Interactive comment on “Prediction of geomorphologic parameters of catchment without GIS to estimate runoff using GIUH model” by P. Keshtkaran and T. Sabzevari

Answers to referee 1

Fig. 1: Drainage network map
a) Heng-Chi catchment b) Gagao catchment c) Kasilian catchment

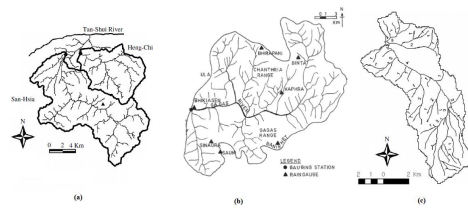
Question16: Figure 1: Why only Kasilian and Gagas? If you do not have the map for Heng-Chi, please delineate it from the SRTM DEM. The maps of Kasilian and Gagas could be originally delineated from DEM as well. Answer 16: The map of Heng-chi has been added as figure1(In revised manuscript).

Fig3: GIS-based stream-order-law ratios versus predicted SOLR

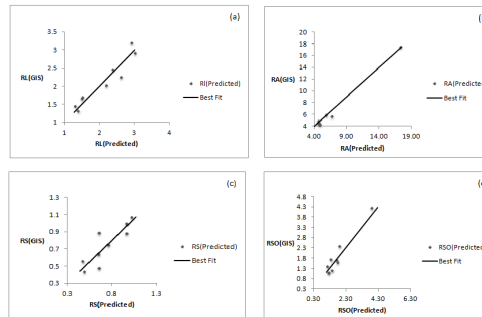
Question21: Section 5: You just write out these equations followed by correlation coefficients, without any figures to show the match between the estimated and GIS-based stream-order-law ratios and GP. I really doubt the credibility of the correlation coefficients. Answer 21: You are correct. Figure3 (In revised manuscript) shows the GIS-based stream-order-law ratios versus predicted SOLR
